Access Compliance Report

Public Rights-of-Way (Curb Ramps)

Intersection ID: 42581	Main Street: GERALDINE_POWE_DR	Cross Street: RISING_OAK_DR	Location: SW
ADA ID: DE7E981FA06F	Ramp Type: BlendTrans1	Initial Pass/Fail: Pass	Overall Compliance: No
Severity Score: 10.25			
Codes/Mitigation Info/Possible Solution		Field Measurements/Component Compliance

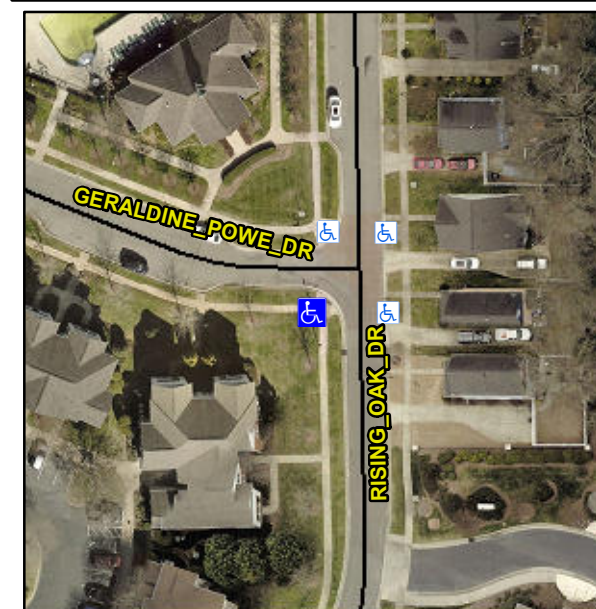
Not Found, R304.5.3, R304.2.2-Perp, R304.3.2-Para, R305.1.4, R305.2, R302.7.2

Compliance	Description	Data	Compliance	Description	Data
N/A	Ramp Length (in)	96.0	Yes	BlendTrans Slope (%)	3.1
Yes	Ramp Width (in)	59.0	No	BlendTrans XSlope (%)	4.0
N/A	Flare Type LT	Sloped	N/A	Flare Type RT	Sloped
N/A	Flare Slope LT (%)	9.9	N/A	Flare Slope RT (%)	3.9
N/A	Flare Traversable LT?	No	N/A	Flare Traversable RT?	No
Yes	Landing Length (in)	48.0	Yes	DWS Provided?	Yes
Yes	Landing Width (in)	59.0	Yes	DWS Contrast?	Yes
No	Landing Slope (%)	2.6	Yes	DWS Length (in)	24.0
No	Landing X Slope (%)	4.8	No	DWS Full Width?	No
N/A	Landing Curb? (Y/N)	No	No	DWS Offset (in)	5.0
N/A	Shared Landing?	No			
Yes	Gutter Ponding?	No	Yes	Gutter Slope (%)	4.1
No	Gutter Lip Ht (in)	0.5	No	Gutter X Slope (%)	2.7
N/A	Painted X Walk1?	No	N/A	Painted X Walk2?	No
	X Walk 1 Direction	To E		X Walk 2 Direction	To N
	X Walk 1 Width (in)	N/A		X Walk 2 Width (in)	N/A
	X Walk 1 Slope (%)	3.1		X Walk 2 Slope (%)	3.7
	X Walk 1 X Slope (%)	3.3		X Walk 2 X Slope (%)	1.7

N/A	Ramp inside XWalk1?	N/A	N/A	Ramp inside XWalk2?	N/A
	Road Slope (%)	1.8		Clear Space?	Yes
	Road X Slope (%)	0.8	N/A	Clear Space to XWalk (in)	N/A
Yes	Any Obstructions?	No	Yes	Storm Grate/Utility Hazard?	No
	Obstruction Type			Storm Grate/Utility Type	
		N/A			N/A
			Yes	Surface Condition? (G/P)	Good
			No	Curb Slope (%)	11.9

Remove & Replace Curb Ramp With Two New Directional Ramps or Equivalent. Remove & Replace Gutter.
